## VILLAS AT STONEBROOK JSP17-62

# PLAN REVIEW CENTER REPORT

Preliminary Site Plan with a Special Land Use

PULTE HOMES  
THE VILLAS AT STONEBROOK  
ALTERNATIVE MITIGATION PLAN  
LAYOUT PLAN

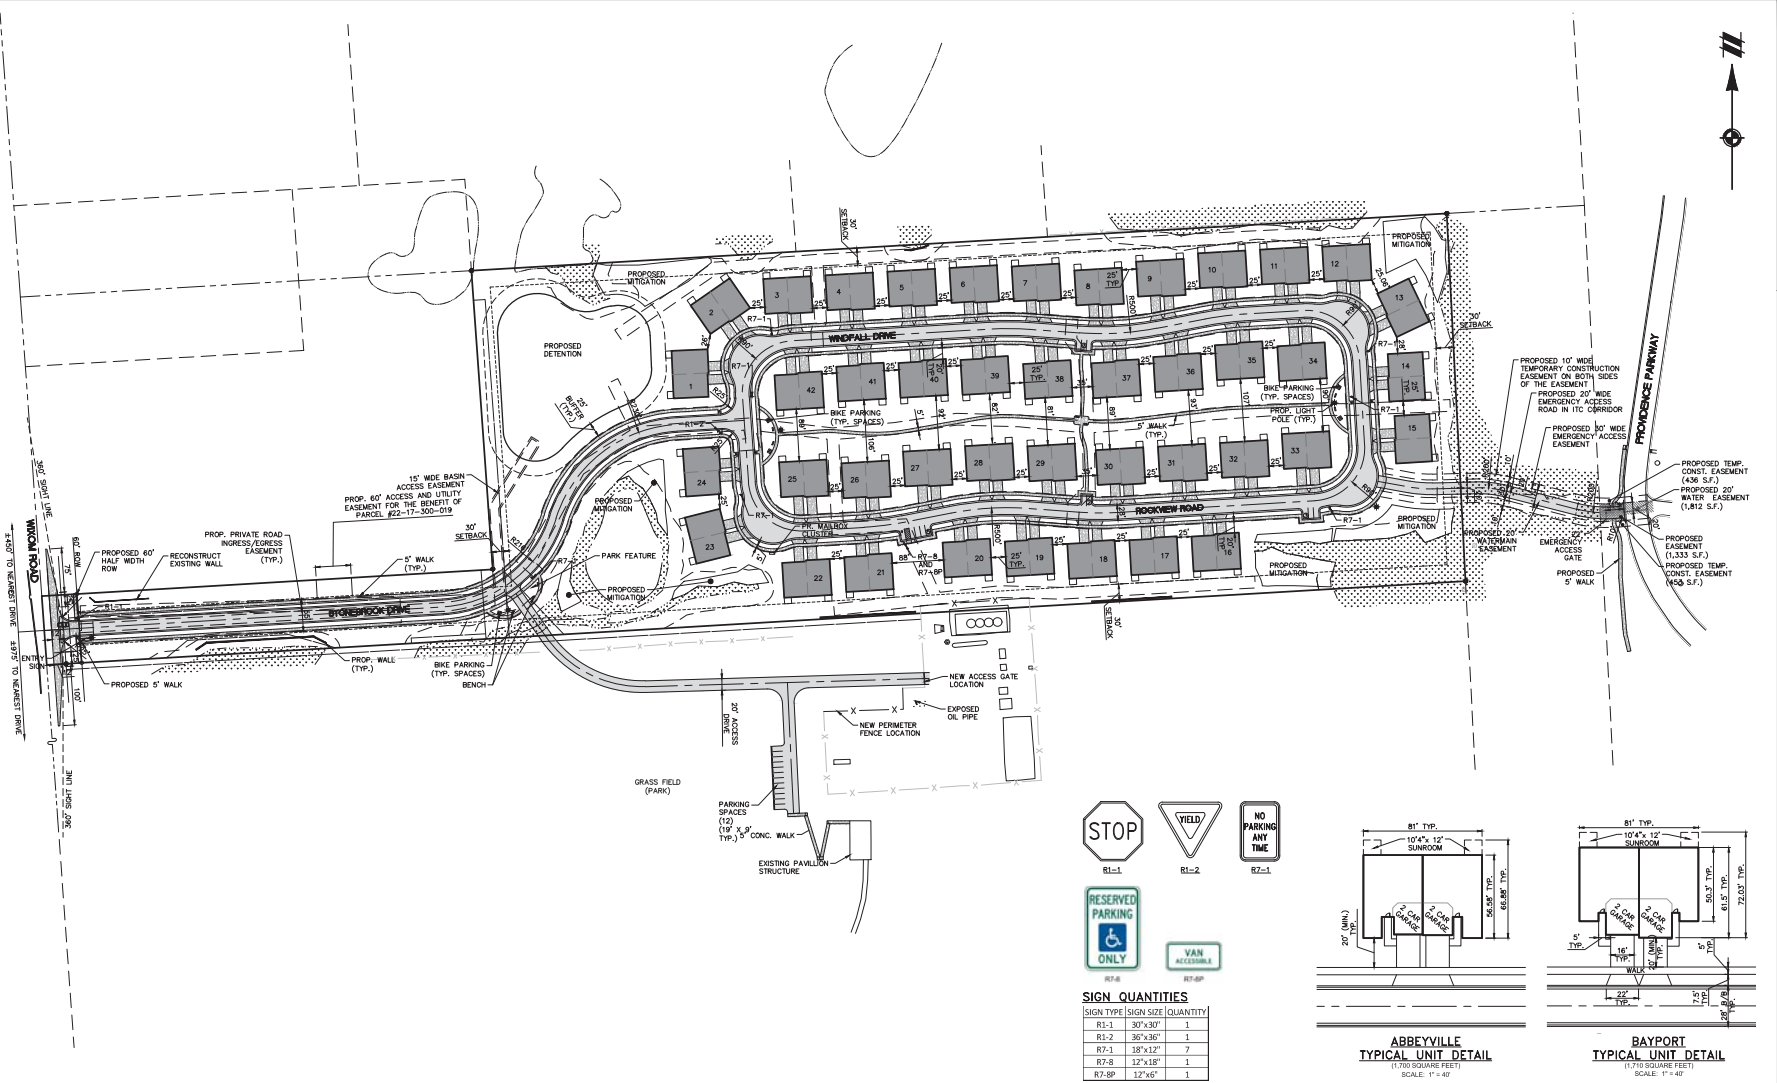
3. Alternative Mitigation Plan: The applicant will need to provide wetland mitigation for impacts to the wetlands. The applicant would prefer to propose off-site mitigation, but has not determined a suitable off-site location. The applicant has provided an alternative plan indicating that if such off-site mitigation cannot be located prior to final site plan approval, the applicant intends to construct "Plan B" showing on-site mitigation on-site (adjacent to existing wetland areas) with the reduction of two units, if this alternate plan is implemented.
4. Conservation Easements: Draft conservation easements are required along with Final Site Plan submittal.

It should be noted that the proposed wetland impact area on the Alternative Mitigation Plan has increased to 0.63-acre, requiring 0.95-acre of proposed wetland mitigation (at 1.5-to-1.0 mitigation ratio). This Alternative Plan is proposing to create 1.0 acre of on-site wetland mitigation in a total of eight (8), individual wetland mitigation area cells. While it is preferred that development plans requiring wetland mitigation provide on-site wetland mitigation, it is also recommended that the proposed mitigation areas be as large as possible as small, fragmented wetland mitigation areas are not as desirable, and sometimes not as successful establishing, as a larger mitigation area.

Figure 1. Highlighted sidewalks shall be six feet in width.

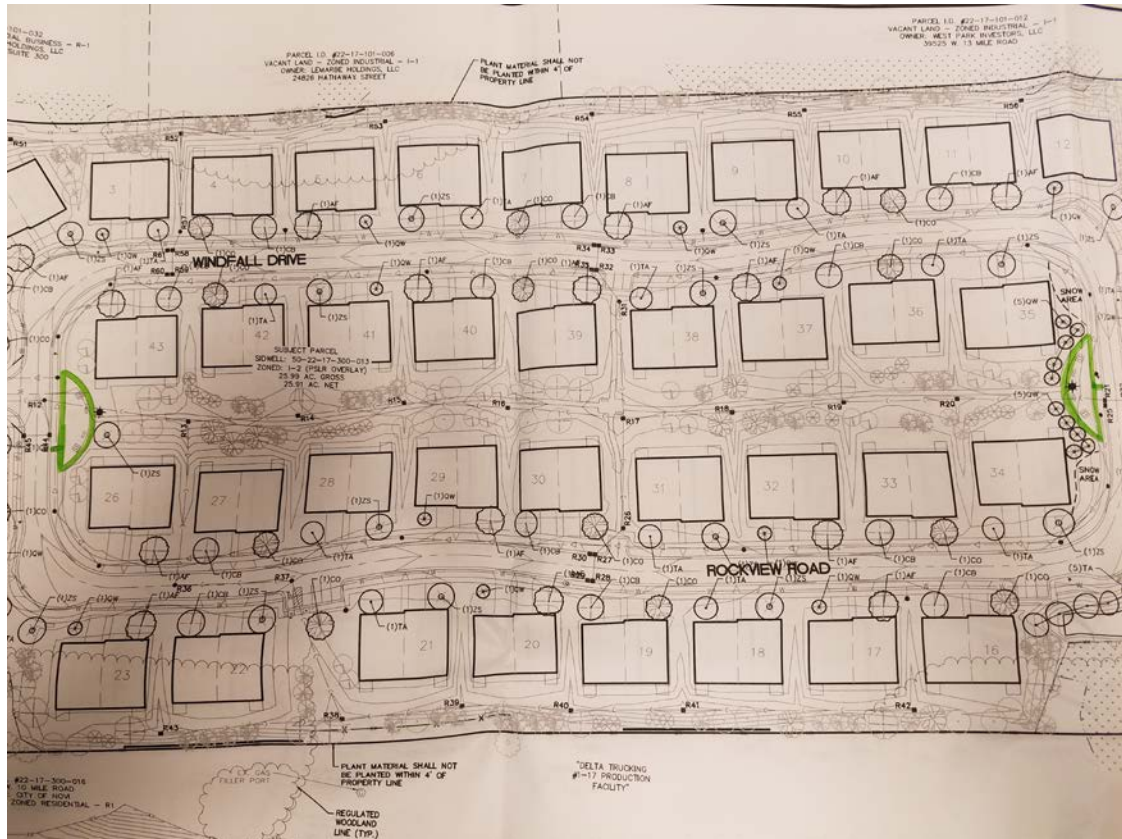
- d. The applicant has provided a total of 20 bicycle parking spaces, which exceeds City requirements (18 spaces – one space for every five units). The bicycle parking locations and layout details are generally in compliance with City standards. The applicant should review and revise the following as necessary:

- i. All bicycle parking spaces shall be accessible via a six foot paved route from the adjacent street. See Figure 1 for clarification on which sidewalks shall be six feet in width.
